Access Compliance Report

Public Rights-of-Way

(Curb Ramps)

Intersection ID: N/A	Main Street: PROVIDENCE_RD	Cross Street: N/A	Location: NE
ADA ID: E2262CFF2E53	Ramp Type: PerpDiag	Initial Pass/Fail: Pass	Overall Compliance: No
			Severity Score: 10.25

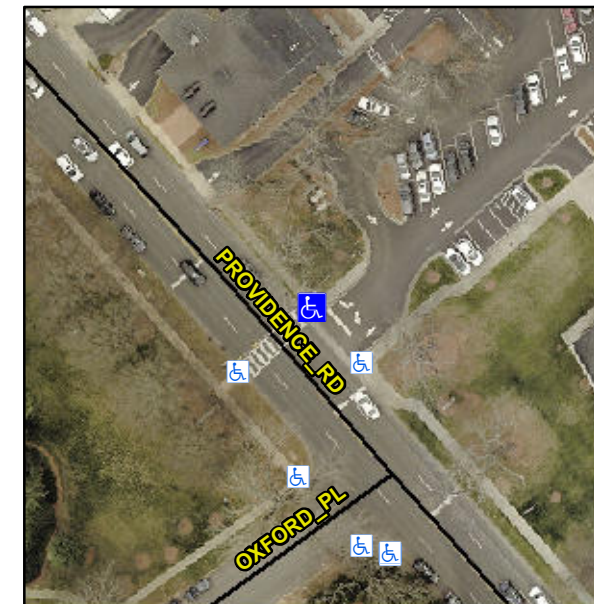
R304.5.3, R304.2.1, R304.2.2-Perp, R304.3.2-Para, R305.2

Compliance	Description	Data	Compliance	Description	Data
N/A	Ramp Length (in)	60.0	Yes	Ramp Slope (%)	7.9
Yes	Ramp Width (in)	48.0	No	Ramp XSlope (%)	3.3
N/A	Flare Type LT	Sloped	N/A	Flare Type RT	N/A
N/A	Flare Slope LT (%)	0.4	Yes	Flare Slope RT (%)	0.3
N/A	Flare Traversable LT?	Yes	N/A	Flare Traversable RT?	Yes
No	Landing Length (in)	N/A	Yes	DWS Provided?	Yes
No	Landing Width (in)	N/A	Yes	DWS Contrast?	Yes
No	Landing Slope (%)	N/A	Yes	DWS Length (in)	24.5
No	Landing X Slope (%)	N/A	Yes	DWS Full Width?	Yes
N/A	Landing Curb? (Y/N)	No	No	DWS Offset (in)	3.0
N/A	Shared Landing?	N/A			
Yes	Gutter Ponding?	No	Yes	Gutter Slope (%)	1.4
Yes	Gutter Lip Ht (in)	0.0	Yes	Gutter X Slope (%)	1.7
N/A	Painted X Walk1?	Yes	N/A	Painted X Walk2?	No
	X Walk 1 Direction	To SW		X Walk 2 Direction	To SE
N/A	X Walk 1 Width (in)	110.0	N/A	X Walk 2 Width (in)	N/A
	X Walk 1 Slope (%)	0.1		X Walk 2 Slope (%)	1.6
	X Walk 1 X Slope (%)	1.3		X Walk 2 X Slope (%)	0.9

Remove & Replace Curb Ramp With Two New Directional Ramps or Equivalent.
